Technical Guidance Committee

Meeting Minutes

Thursday June 8, 2017

Figure Error! No text of specified style in document.-1. Individual treatment system sampling process.

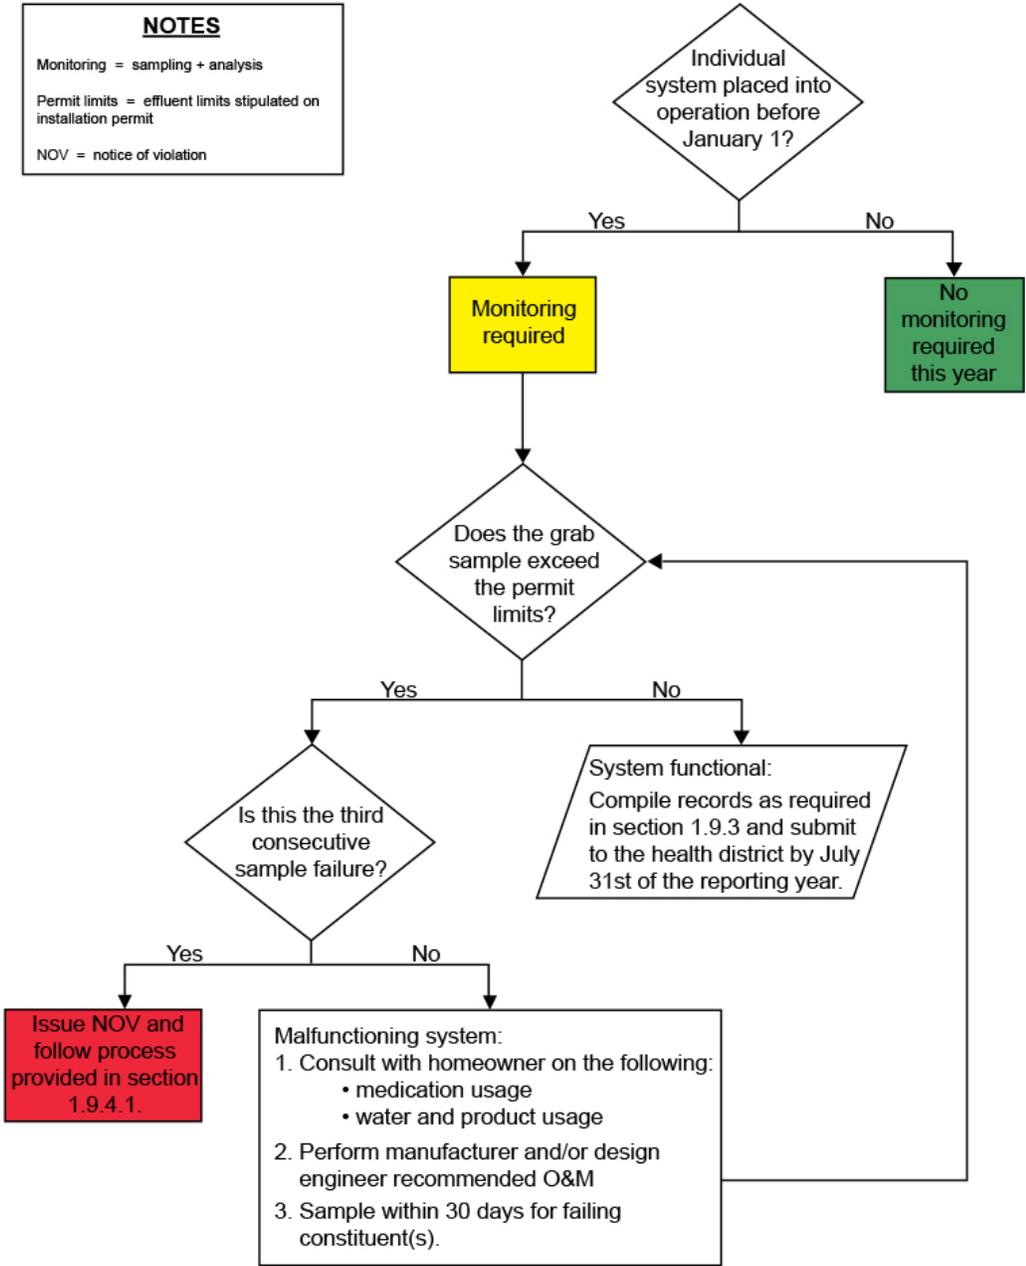
Comment [DP1]: This Instruction needs to be updated.

Infiltrator's Idaho ATL Criteria

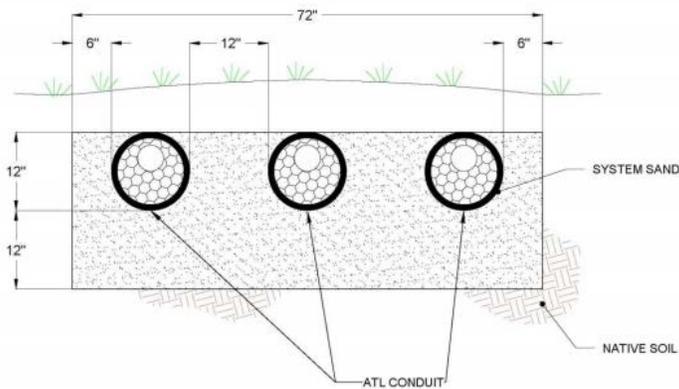
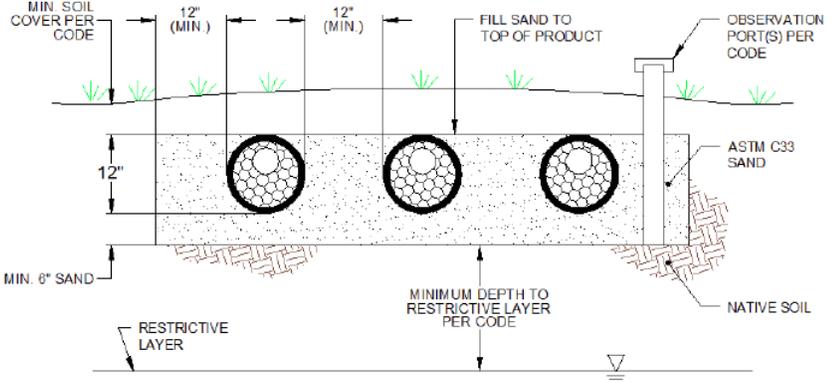
Infiltrator's request for approval and accompanying Design and Installation Manual reflect design parameters which have never been tested and deviate from its NSF Standard 40 certified models. For example, diagrams on pages 5 through 7 all show 6" of System Sand on the outside perimeter. The ATL System was tested with 12" of System Sand around the perimeter. If it were not critical for the ATL System's performance, Infiltrator certainly would have tested the smaller, more competitive model.

The ATL System has also never been tested with 12" of System Sand below their product. In an email chain recently with Adrian Aspenson (Business Development Manager of the NSF Water System division), NSF stated that their engineering department determined that a system would need to be re-tested to change the certified model from 6" of sand to 12" of sand below the product. NSF stated that *"Because you want to certify a 12" bed dept [sic] ... you need [Standard] 40 tested at the same bed depth. 6" bed depth does not translate. This is what engineering conveyed to me and it makes sense."*

Further, the Infiltrator ATL System has only one certified model which reflects their three-bedroom configuration in every other state; Infiltrator has never undergone an engineered review to certify any other flow rates other than for a three-bedroom house.
